CENTRAL NORTH EXTENSION  
RESPONSE TO INFORMATION REQUEST

PREPARED FOR  
**JELLINBAH GROUP PTY LTD**  
ON BEHALF OF THE JELLINBAH EAST JOINT VENTURE

SEPTEMBER 2016

**Figure 3 Receiving Water Monitoring Locations**

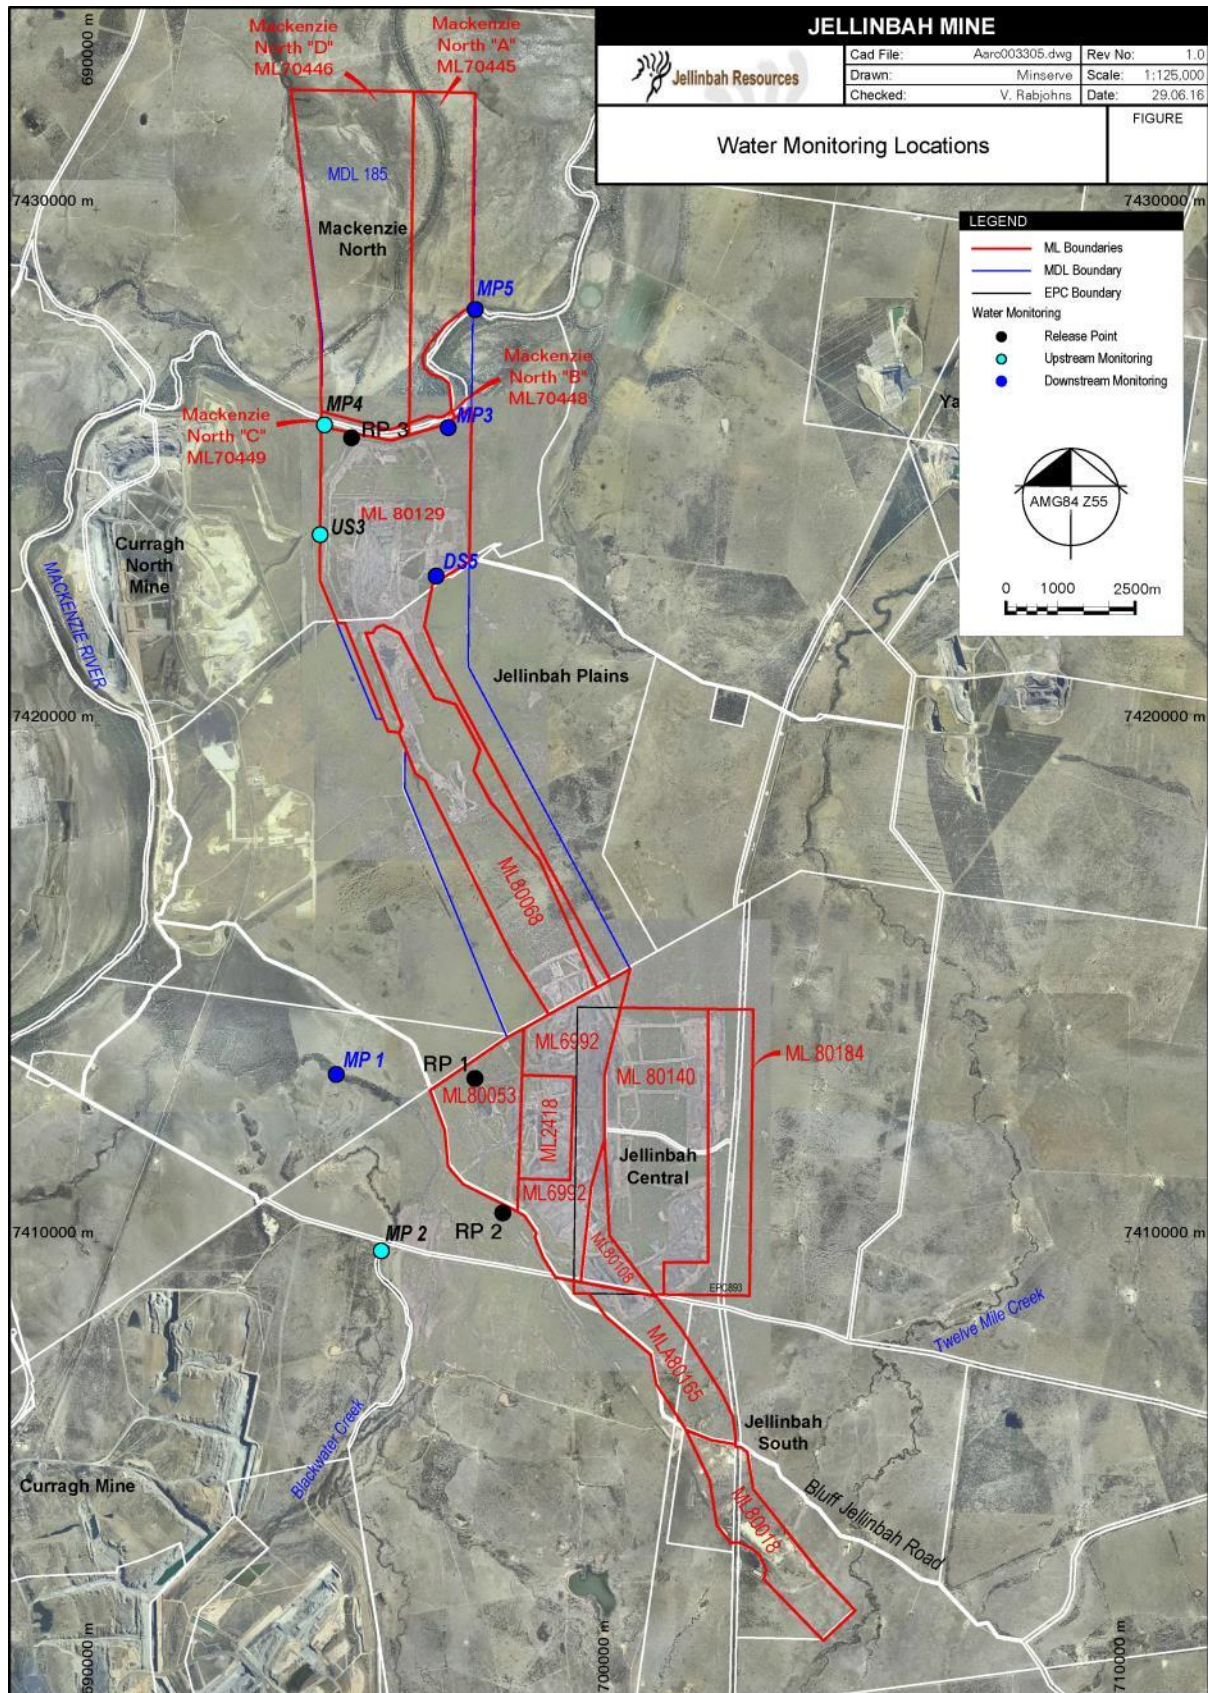
- a) Mine water balance and relevant modelling results;
- b) Data regarding the estimated water quality and quantity expected as part of new operations on the Project;
- c) Details of any likely controlled / uncontrolled releases;
- d) The capacity of proposed new MWMS dams (both regulated and non-regulated structures); and
- e) Proposed monitoring points for the receiving environment.

Monitoring locations for the receiving environment are detailed in Table 7 and shown in Figure 3.

**Figure 7 Site Water Management – Central North Extension**

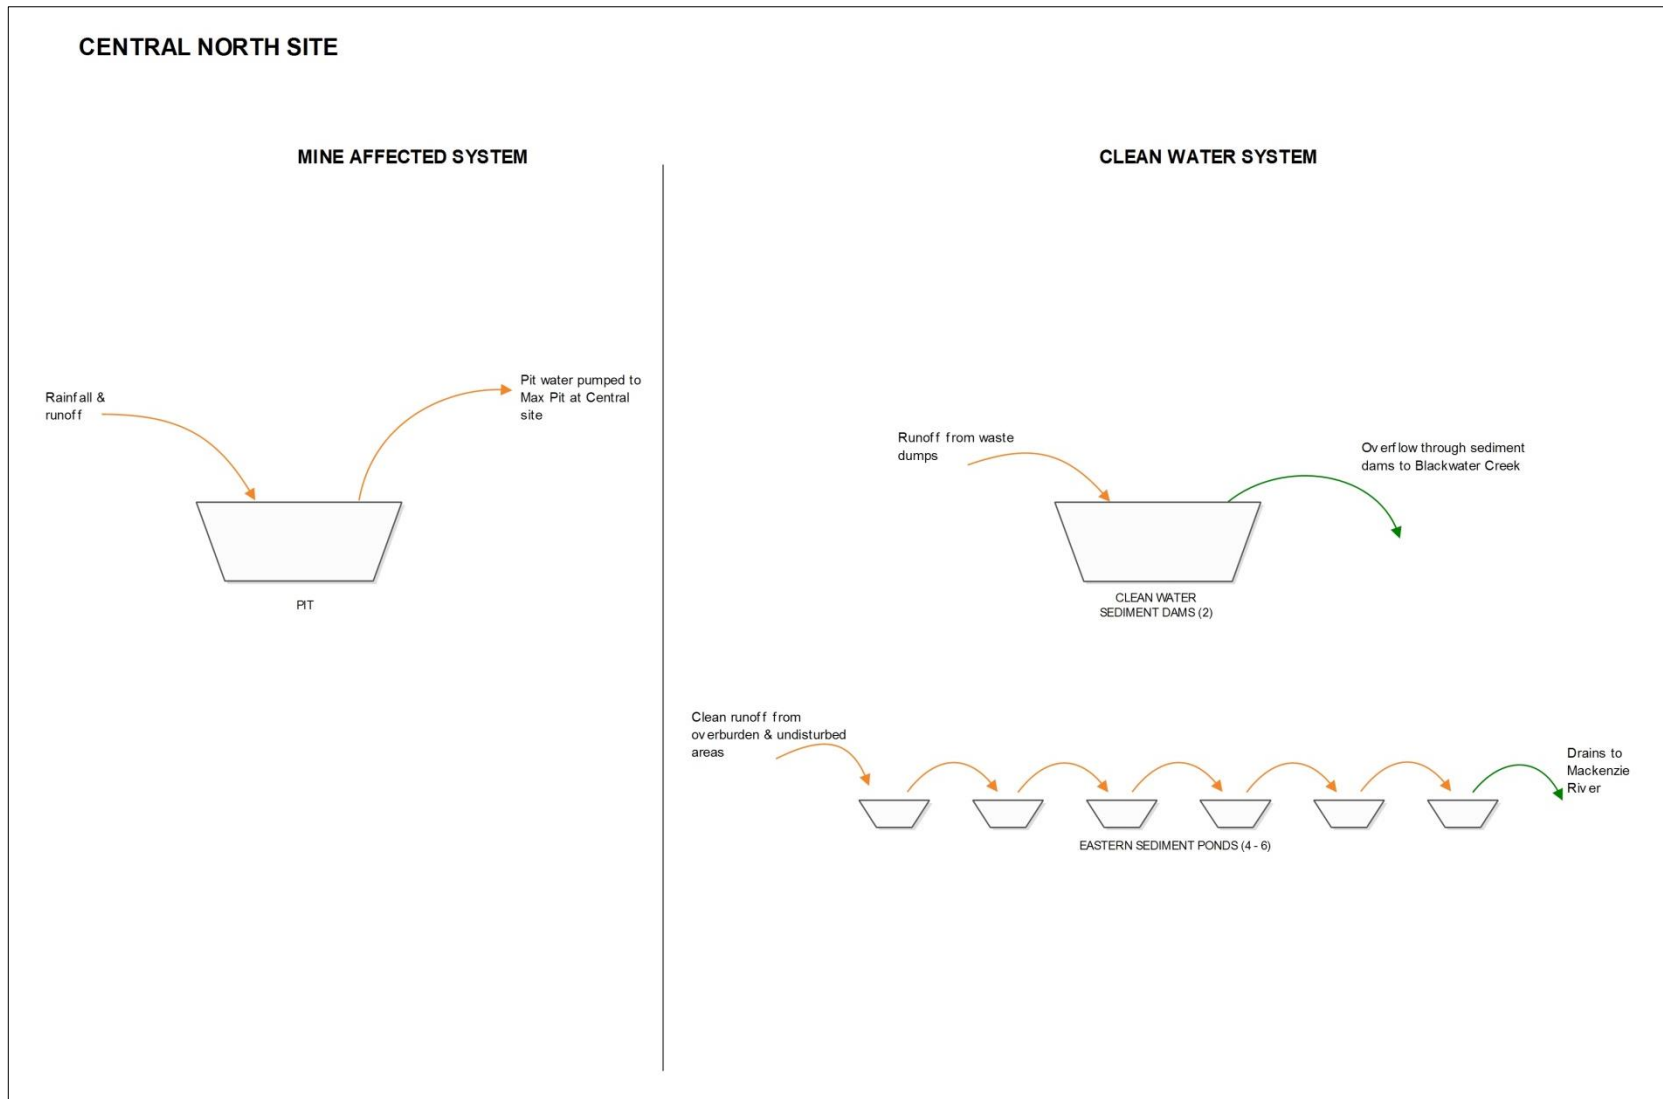
- a) Procedures for the separation and management of mine-affected and clean water on site;
- b) A revised mine water release strategy in the event that MAW is required to be released from the site in the future. This is to include, but is not limited to, the following information:
  - i) The mechanisms that will be implemented to manage such releases;
  - ii) Proposed limits to release rates;
  - iii) Stream flow rates triggers that allow a release;

Development of the Central North pit into the Central North Extension area will require the diversion of natural runoff from eastern areas to the north, away from the open-cut pit. Dedicated open drains with sediment traps will be established in the Central North Extension area, allowing sediment to settle prior to exit from the site. The clean water drain will outlet into the receiving environment near Five Mile Lagoon, subsequently entering the Mackenzie River. This clean water diversion will add approximately 150 ha of undisturbed catchment to the local waterway, which is less than a 2% increase in the total catchment area. This runoff will be clean water as the area to the east will not be affected by mining activities. As such, no significant impact on the receiving environment is anticipated to result from the Central North Extension. Monitoring of this receiving waterway will continue in order to ensure this outcome.

Water management arrangements at Central North and the Central North Extension are illustrated in Figure 7 and described in further detail in Appendix A.

**Figure 9 Groundwater Monitoring Locations**

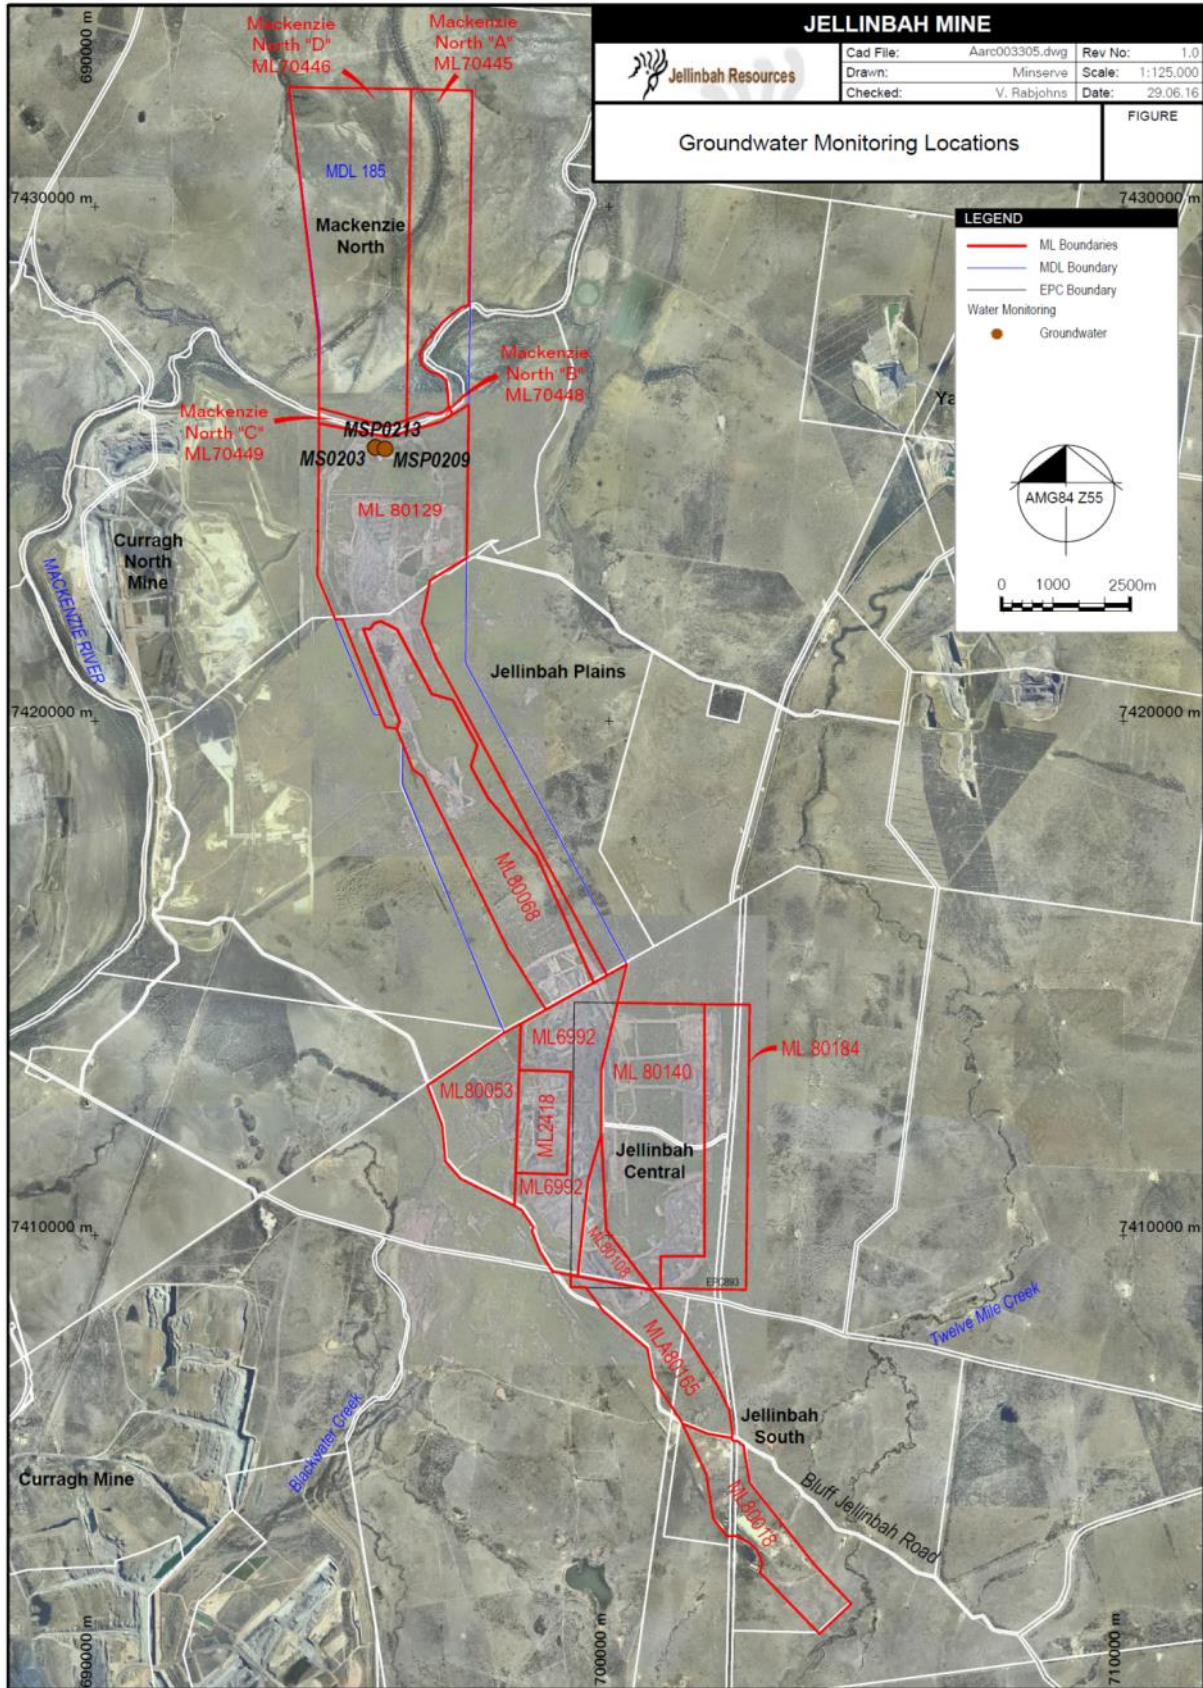
- a) Details of the current groundwater monitoring being undertaken and provide this information relative to Jellinbah Mine and regional groundwater bores; and
- b) Provide up-to-date information regarding other current groundwater users for the area.

Figure 10 Final Voids and Levees – Mackenzie North, Jellinbah Plains and Central North Extension

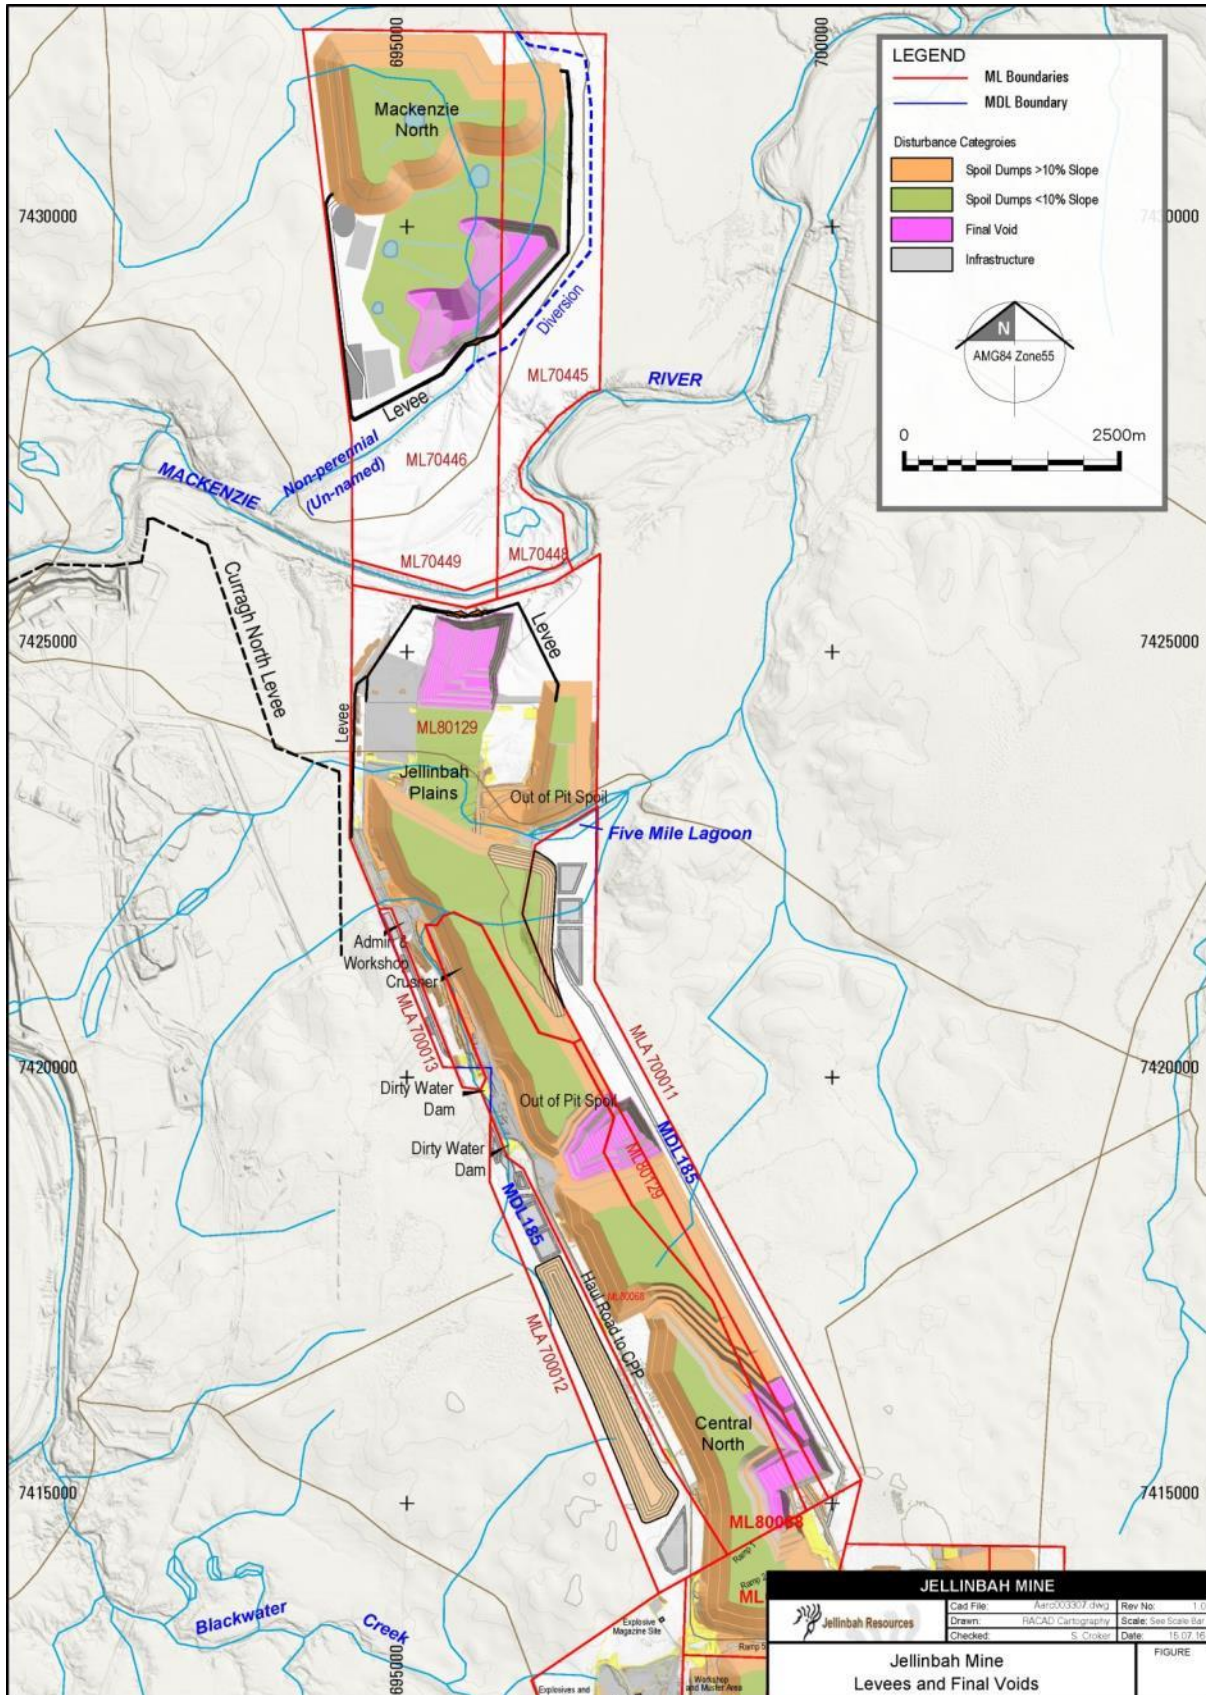
The amendment application states mining operations at Jellinbah Plains are protected from flooding by the Mackenzie River by the ongoing staged construction of a levee built to a 1:1,000 AEP flood event. However, the submitted application states that no additional levees are required for the Central North Extension. The proponent also does not provide maps of figure locations of proposed final voids which may require the construction and placement of diversion banks / levee systems to prevent or divert surface water in flows to final voids / pit.

Two levees are currently approved for the Jellinbah Coal Mine. The levee at Jellinbah Plains has been constructed in its final stage (Stage 3) and is shown in the final conceptual landform in Figure 10. The levee was originally approved following submission of the Environmental Management Plan in June 2006 (AARC 2006). Certified design reports and as-constructed designs have previously been submitted to EHP in accordance with the requirements of the EA.

Figure 10 indicates the location of the proposed Central North Extension final voids in relation to the approved Plains levee. Mining operations within the proposed Central North Extension will be located between the current Plains and Central pits, forming an extension of the approved Central North pit to the east. The proposed location of the Central North final void is within 500 m of its current approved location.
